Re: Rapiscan AIT System Radiation Survey Reporting

Rapiscan systems	Secure 1000 Radiation Emission Measurement	FORM R-0646-1 (Single Pose)
----------------------------	---	--------------------------------

**R-0646-1 Addendum
(Documentation Errors)**

1. In Beam Dose Measurement: Survey Table. 1

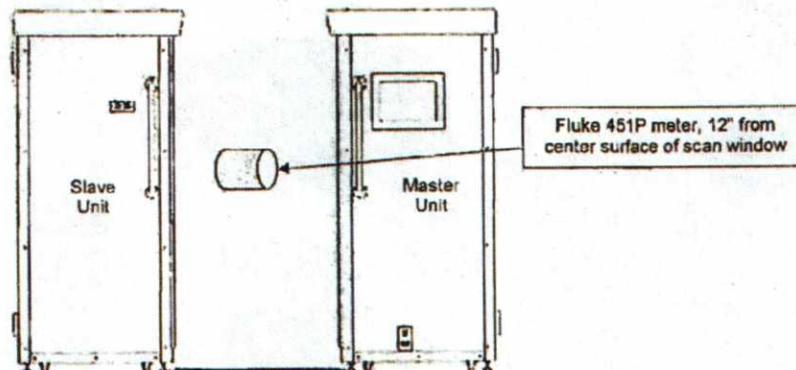
1. No value indicated for background radiation. Typical values range from 7uRem/hr to 13uRem/hr at sea level. Note: Absence of value has no adverse impact on calculations.
2. Technician indicated scan time as 7 seconds. Correct scan time is 3 seconds.
3. TABLE 1: Incorrect presentation of data in Column 6 for Effective Dose. Indicated values are .023 uRem and .120 uRem. It appears the technician may have divided by 10 twice; once in Column 3 and again in Column 6. Corrected values are .23 uRem and 1.2 uRem.

The service technician should attend refresher training.

The corrected data indicates this system was operating within expected parameters. No re-survey is required for this system.
